United States Department of the Interior

BUREAU OF LAND MANAGEMENT
Alaska State Office
222 West Seventh Avenue, #13
Anchorage, Alaska 99513-7504
<http://www.blm.gov>

The enclosed Errata Sheet documents minor changes to the text and figures of the Final Supplemental Environmental Impact Statement (EIS) for the Alpine Satellite Development Plan (ASDP) for the Proposed Greater Mooses Tooth One Development Project that was publicly released in October 2014. These corrections reflect edits that were discovered after the release of the Final Supplemental EIS. We have utilized "tracked changes" (underlined additions and crossed-out deletions) for some of the changes where we felt it would assist the reader to more easily identify the corrections. There are no changes or significant new circumstances or information identified in this Errata Sheet that affect the analysis and conclusions in the Final Supplemental EIS. This Errata Sheet is part of the administrative record for the Supplemental EIS. These corrections will be posted on the BLM-Alaska website at www.blm.gov/ak/GMT.

Attachment 1: Fish Creek Wind Rose

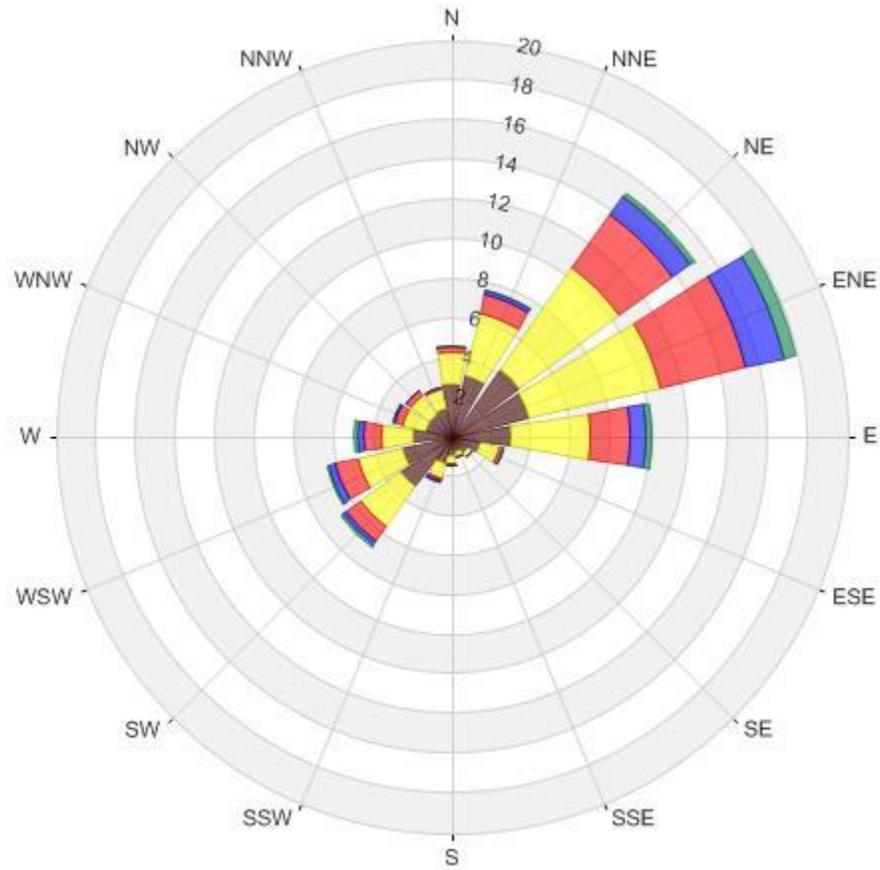
3.2.3.1	111, 112	The Fish Creek data as shown in the windrose is not similar to Nuiqsut as suggested by the test. The distribution of wind directions is similar; however, the distributions of speeds is are not. Nuiqsut has only 3% of wind speeds above 11 m/s. and the Fish Creek windrose shows 30% of measurements above 11 m/s and is now corrected to show no more than 2% above 11 m/s. This difference is too large to be real; therefore, it is probable that one of the datasets is being plotted incorrectly and should be revisited . Also, the % difference in calms between the 2 sites can be due to local conditions. However, wind speed sensor sensitivity may also be a factor. The Nuiqsut sensor likely has a lower sensitivity threshold. In other words, the Nuiqsut sensor will begin to accurately record values at a lower wind speeds compared to Fish Creek Please see Attachment 1: a corrected wind rose for the Fish Creek station which used wind speeds in meters per second to match the Nuiqsut wind rose.
